LANDSCAPE and LIGHTING PLAN
Twin Magnolias Condominiums
Conditional Use Permit

STAFF REPORT

DATE: October 17, 2002

PROJECT: A request for a Conditional Use Permit to allow a condominium development consisting of twenty-two (22) two-family apartments (Use 1.241) and one existing single-family dwelling (to remain) (Use 1.111) at 107 Jones Ferry Road.

SHEET NO. UP4
OF 15

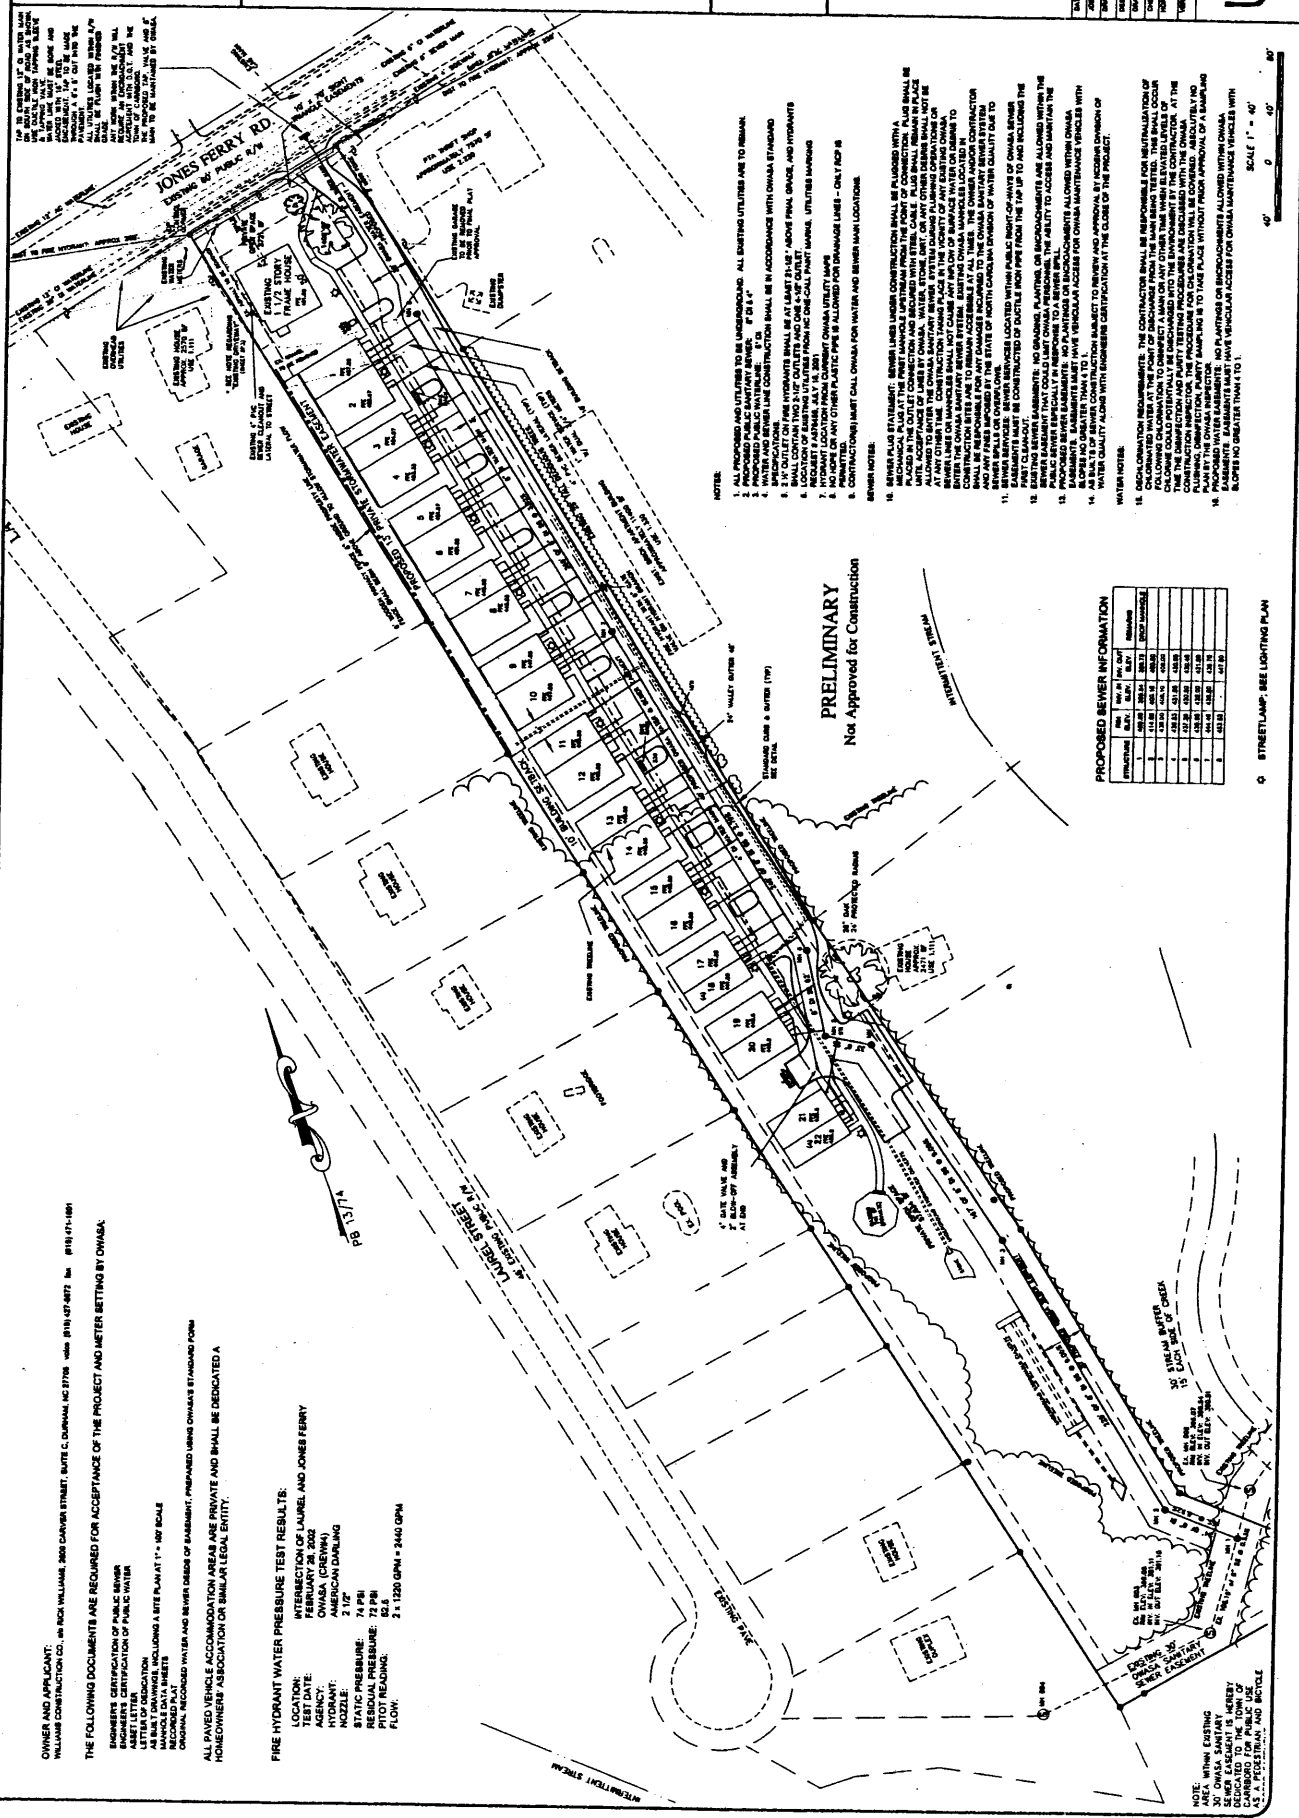
OWASA water and sewer is available to the site, each from a different location. Water service would connect to an existing line in the Jones Ferry Road right-of-way. Sanitary sewer service would be provided via an eight-inch (8") line that would tie in to an existing line at the southern end of the property (**Attachment A, Page UP4**). Both lines would be contained in an OWASA easement that would run in a north-south direction from the north end of the property (i.e.- Jones Ferry Road) to the south end of the property. The easement would be thirty-feet (30') wide except where the water and sewer lines run parallel (in front of the dwelling units) where it would increase to forty-feet (40') wide, to accommodate the minimum separation distance required between lines. OWASA has indicated to the Zoning Division that it is acceptable for the project to receive a CUP at this point; however, OWASA staff did request that one recommendation be included on the permit. During the last plan review for the project, OWASA realized that the waterline is shown connecting to a line to be used for recycling water in the near future (referred to as a 'cogeneration line'). Other options for connection do exist in the Jones Ferry Road right-of-way, and OWASA is comfortable with a new connection being shown on the construction plans for the project. Therefore, per OWASA, staff recommends that the following condition be attached to the permit:

- That the construction plans must show the waterline connecting to a main line other than the cogeneration line in the Jones Ferry Road right-of-way.

- That the construction plans must show the waterline connecting to a main line other than the cogeneration line in the Jones Ferry Road right-of-way.

SHEET NO. **P5** OF 13

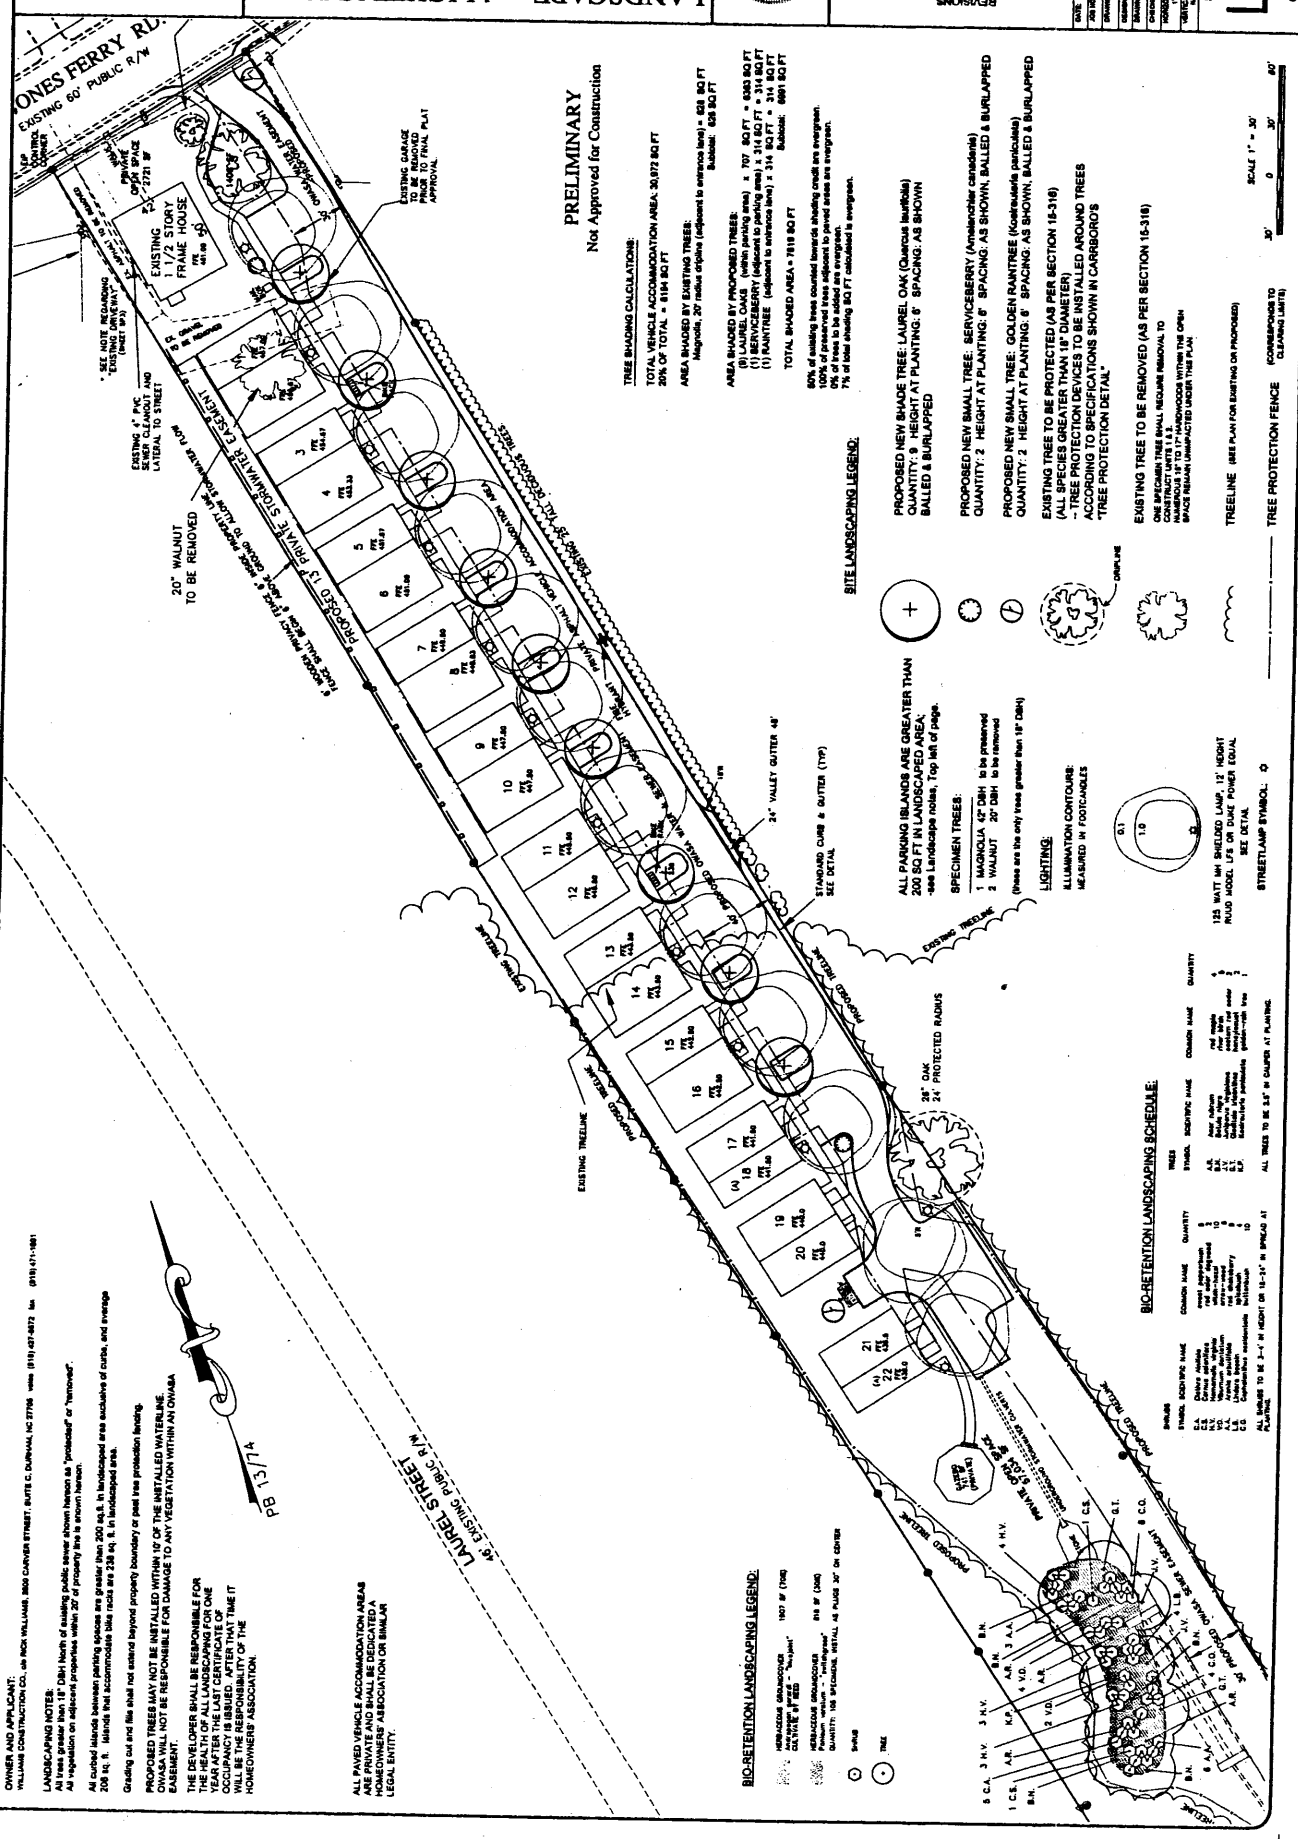
Only two (2) specimen trees were identified on the site (a 42" magnolia tree and a 20" walnut tree). One of the two, the 20" walnut tree, is located in the proposed location of the first two-family apartment building, and therefore would have to be removed during construction. Town staff (both Planning Department staff and the Town Arborist) extensively discussed with the applicant the possibility of saving the existing 42" magnolia tree near Jones Ferry Road, and ultimately, it was determined that the tree could be saved by shifting the location of the driveway as far to the east of the tree as practicable. Some amount of trimming may be required so that vehicles may enter and exit the site without conflicting with the tree, but the tree will remain. One other specimen tree (26" oak) was identified on the adjacent property to the east very near the property line separating the two properties. As described earlier, the driveway has been shifted to the west in the area of this tree, so as to avoid the root zone of the tree during construction.

Section 15-317 of the LUO requires a 20% minimum shading of the project's vehicle accommodation area (driveway/parking lot). In accordance with Appendix E-3 of the LUO, the project exceeds this requirement by including nine (9) laurel oak trees, one (1) serviceberry tree, and one (1) raintree, in addition to the retention of the existing 42" oak tree (**Attachment A, Page L5**). All proposed trees would be located along the vehicle accommodation area. The 30,972 sf of vehicle accommodation area requires 6,194 sf of shading. The total amount of shading provided amounts to 7,619 sf, which exceeds the requirements of the LUO. According to Appendix E, E-12, of the LUO, laurel oaks are considered nearly evergreen when used in the Piedmont region of North Carolina (they are listed under 'Evergreen Shade Trees'). Therefore, the proposed trees should provide some winter shading and winter color.
